ADDENDUM NO. 3

Project: City of Whitefish Wastewater Treatment Plant Improvements Project - 2019

Date of Addendum: October 23, 2019

SKS
SKS-8
 (HALF SCALE)

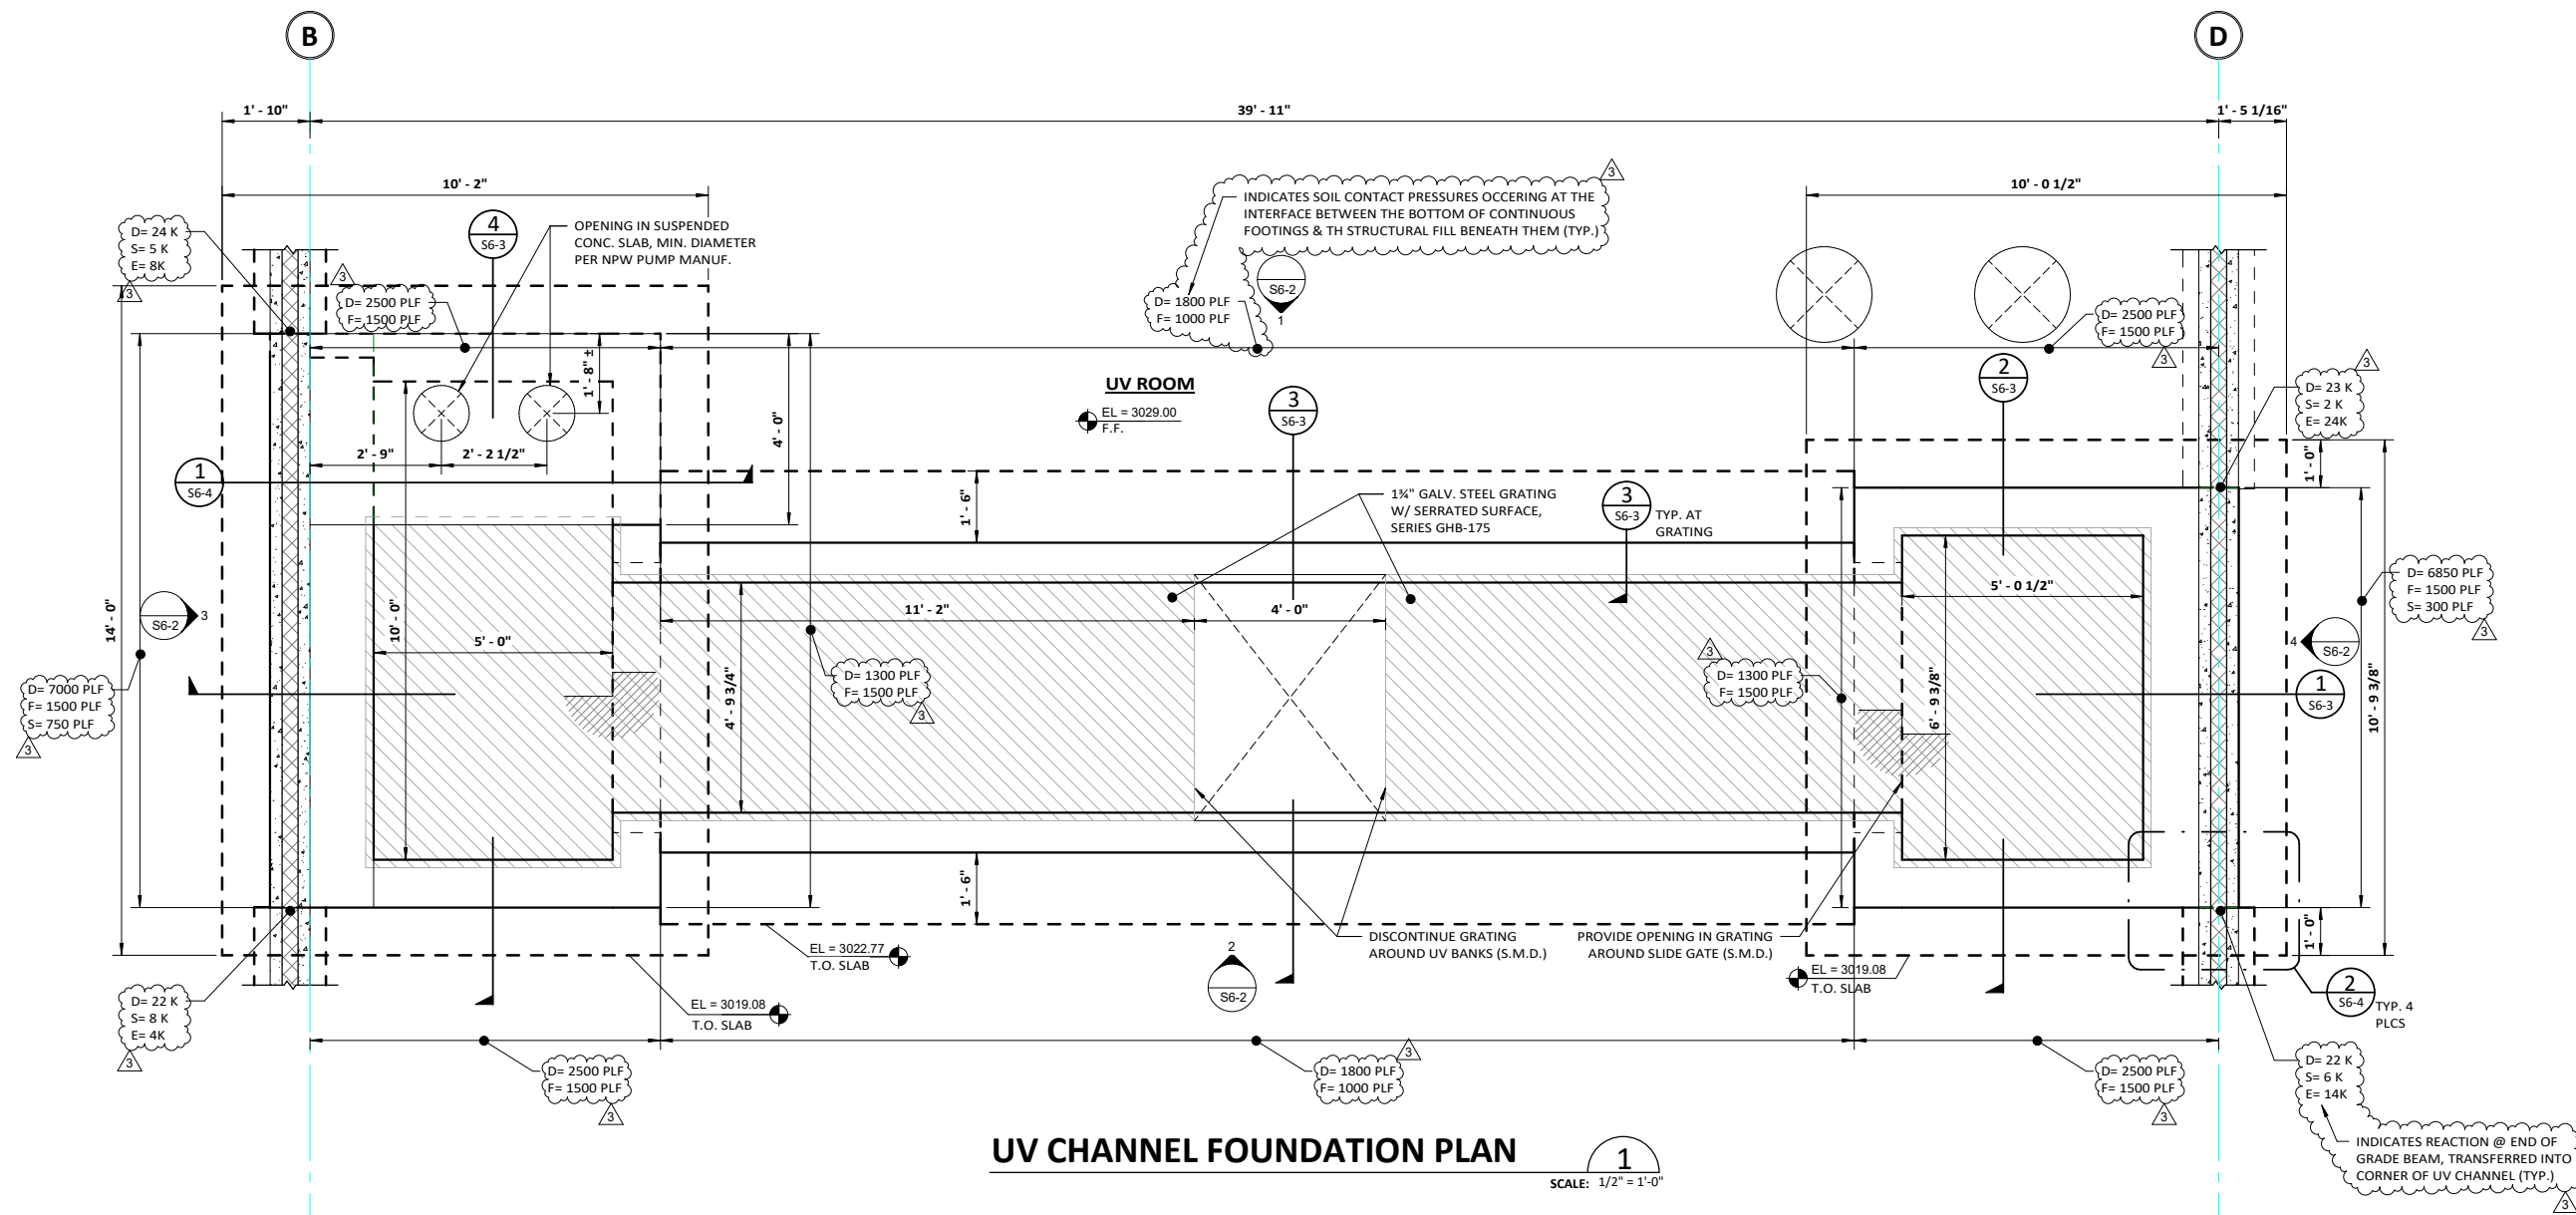
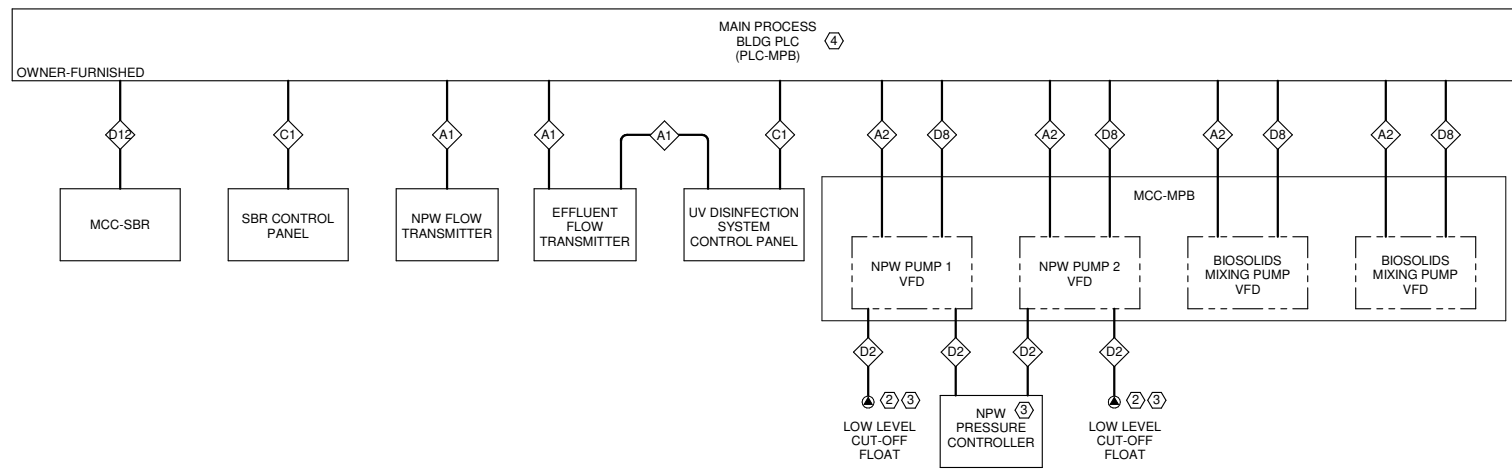
13. Sheet S6-1 – Detail 1

Detail 1 on Sheet S6-1 is revised as per SKS-8 attached.

3 MAIN LIFT STATION PLC CONTROL ONE-LINE DIAGRAM
E0-5 NOT TO SCALE

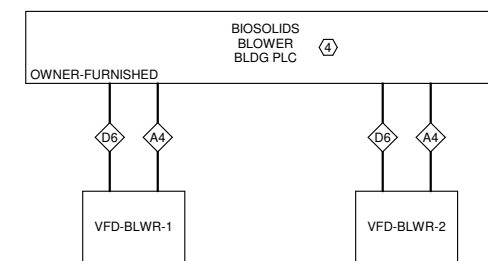
21. Sheet E0-5

See revisions made to Detail 3 - Main Lift Station PLC Control One-Line Diagram. Revised Sheet E0-5 attached.

Sheet
E0-11

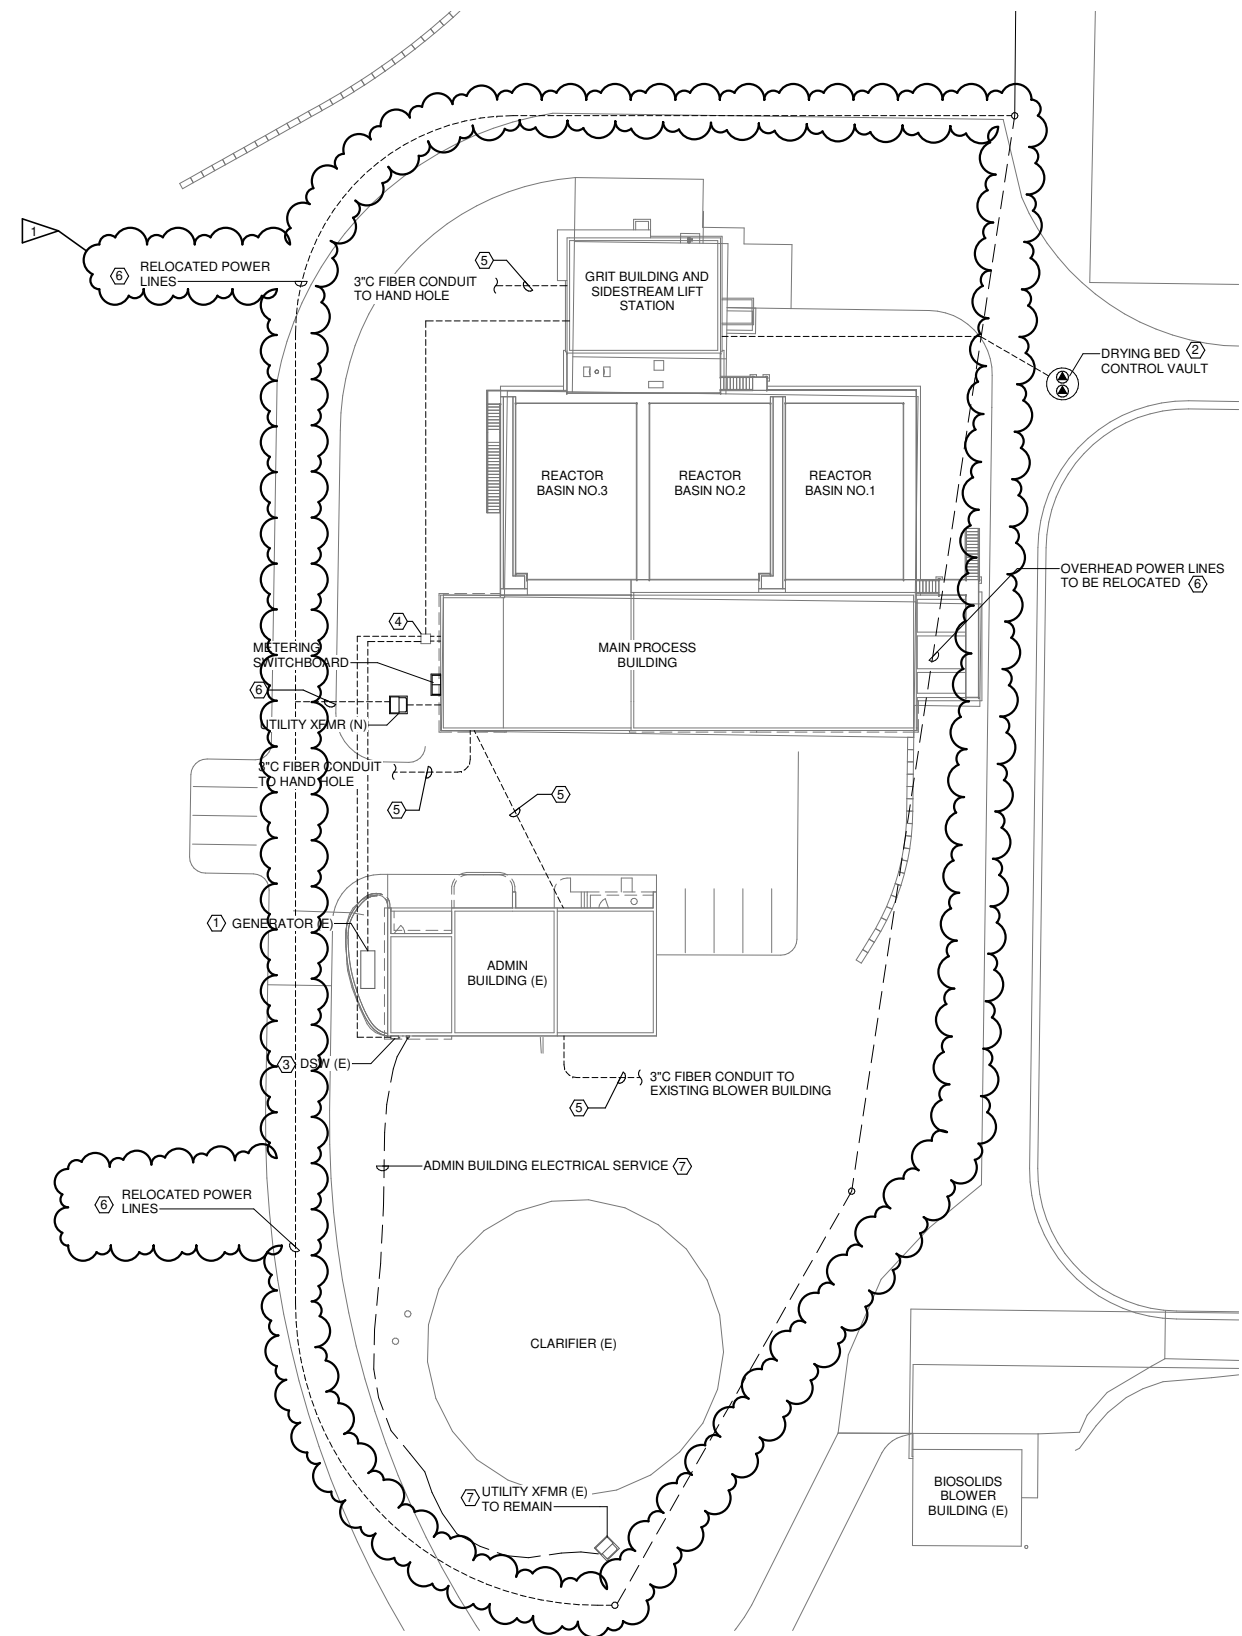
22. Sheet E0-11

See revisions made to Electrical Site Plan. Revised Sheet E0-11 attached. Note the utility provider (not the Contractor) will be responsible for relocating all high-voltage line to the existing transformer south of the existing clarifier.

Sheet
Fig. AD3-1

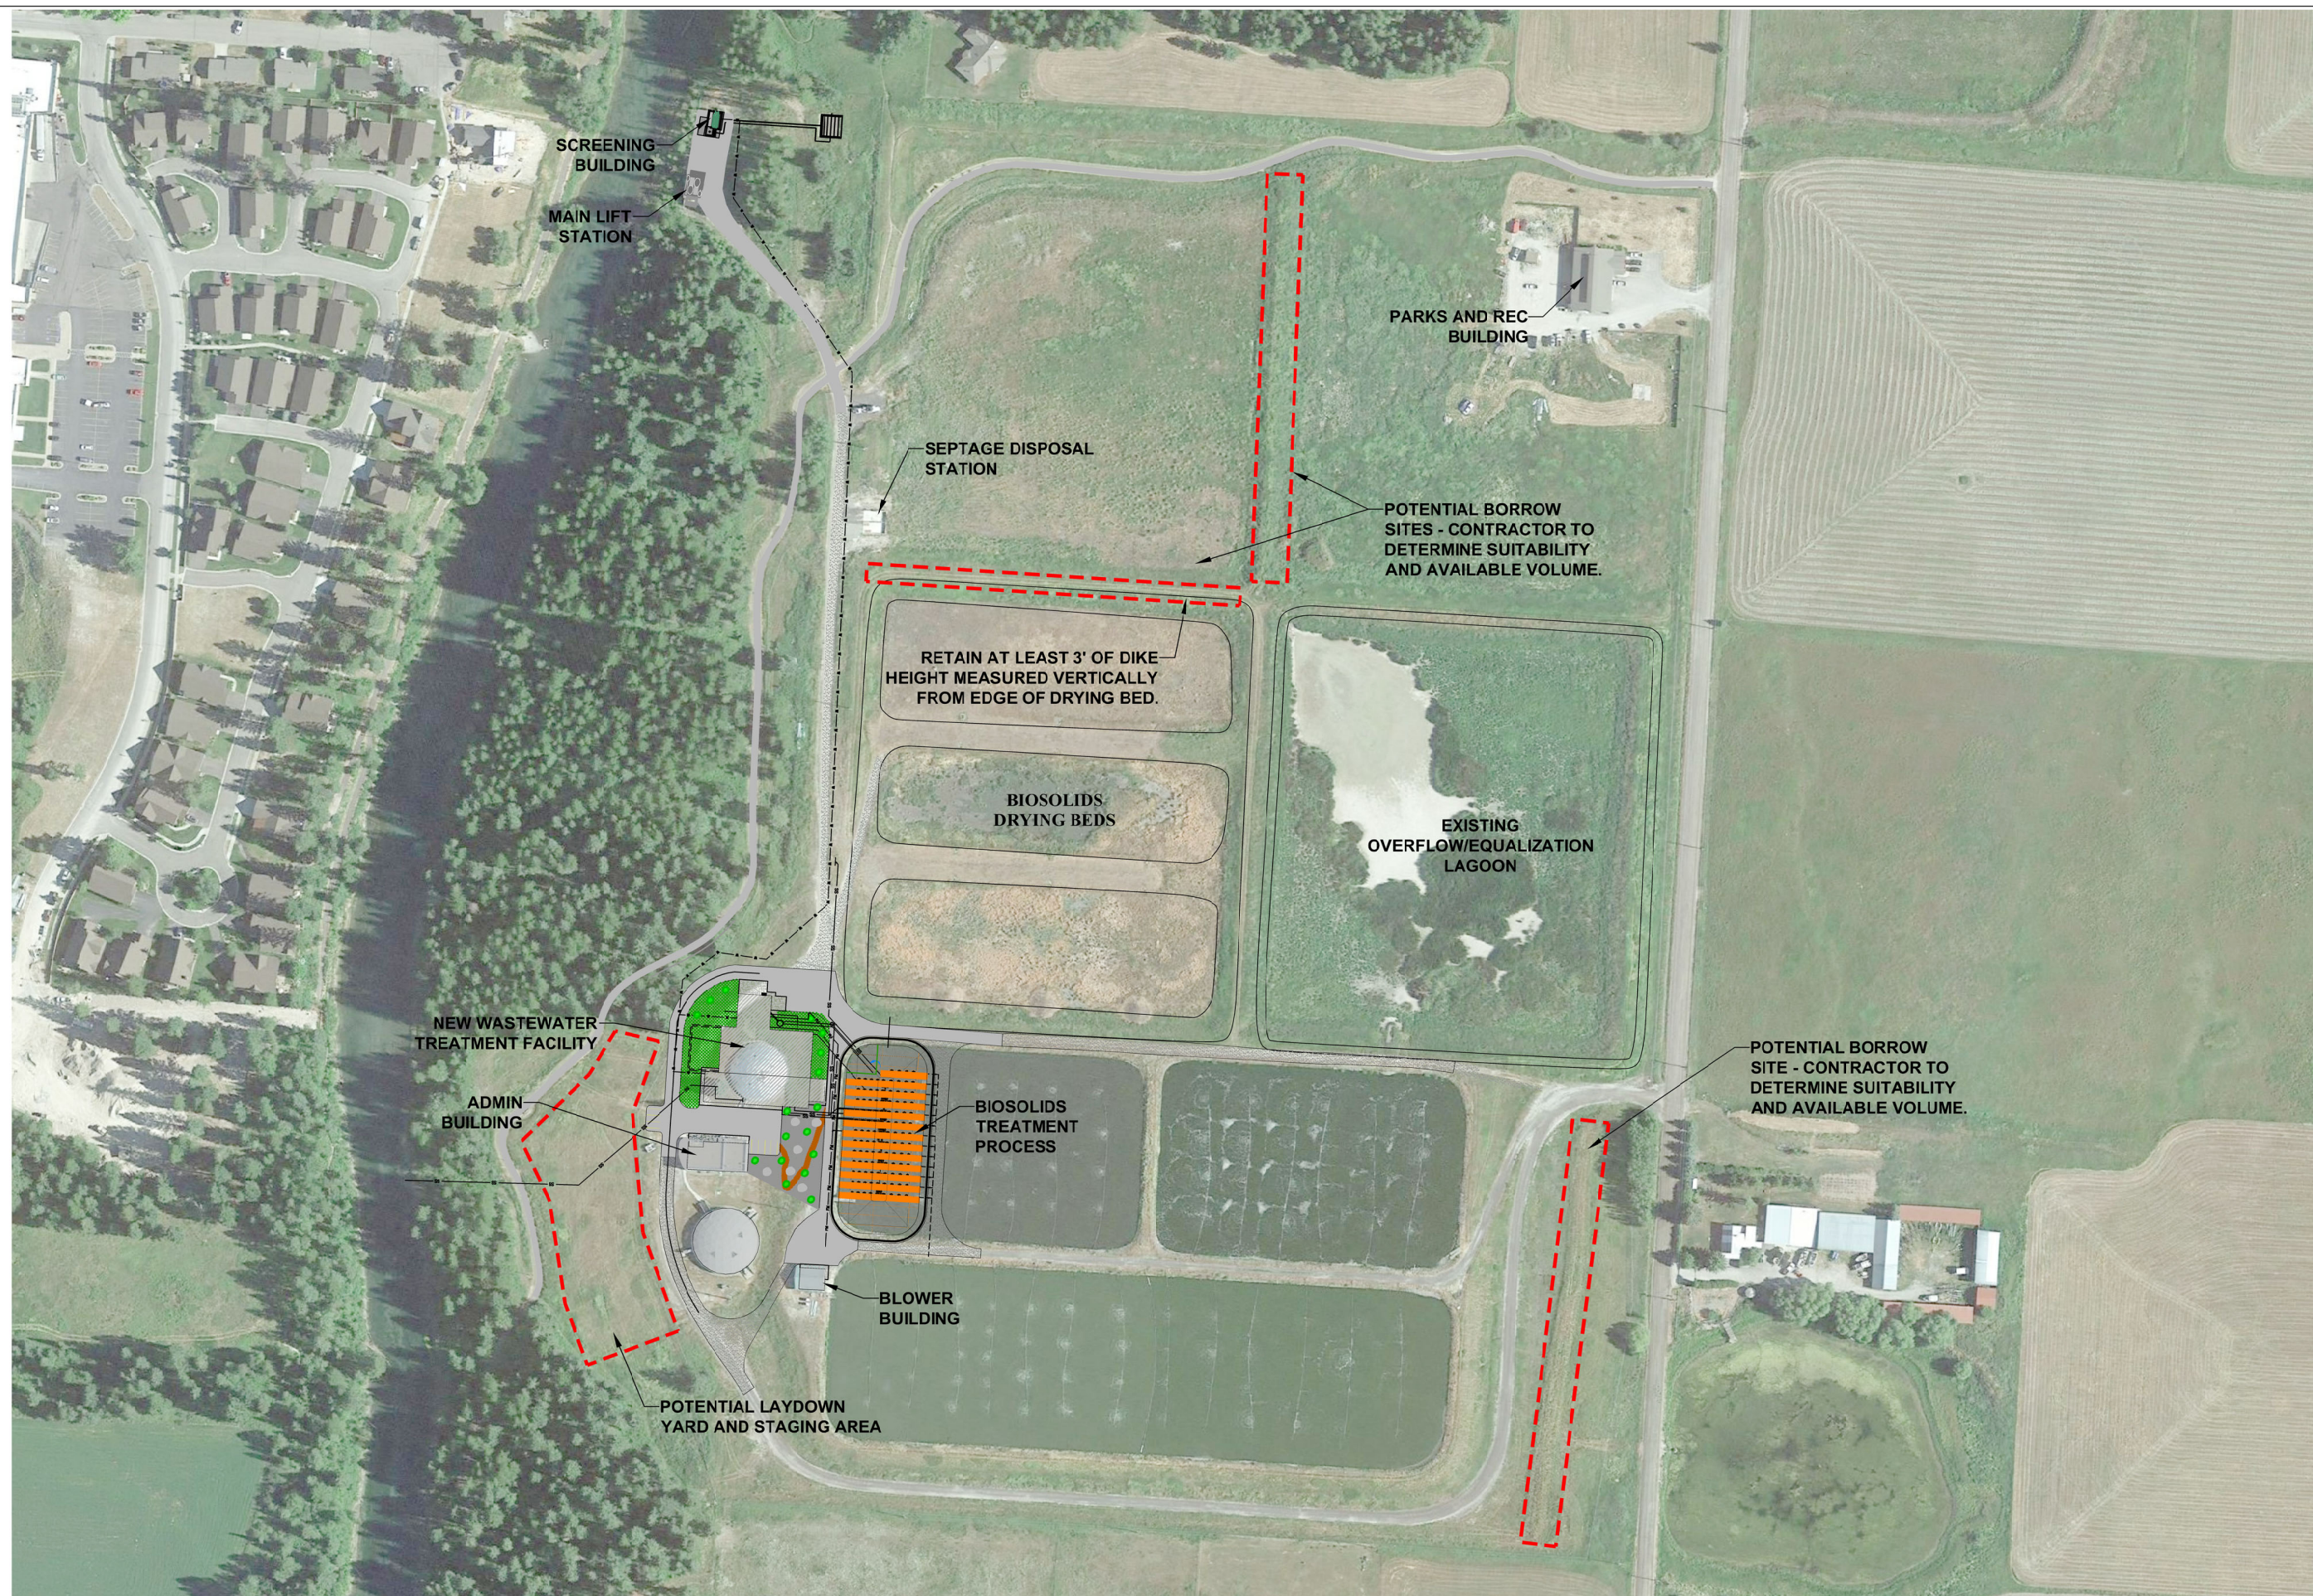
- The area west of the treatment facility can be utilized as a laydown yard provided it is reasonably well maintained, secured from the public and properly restored after the project is complete. See attached figure AD3-1.

- Some onsite materials may be available to the contractor as imported embankment for construction of the Biosolids Basin dike as well as the westerly access road. Suitability of this material has not been established. See attached figure AD3-1 for what onsite materials the Contractor may utilize if suitable for embankment.
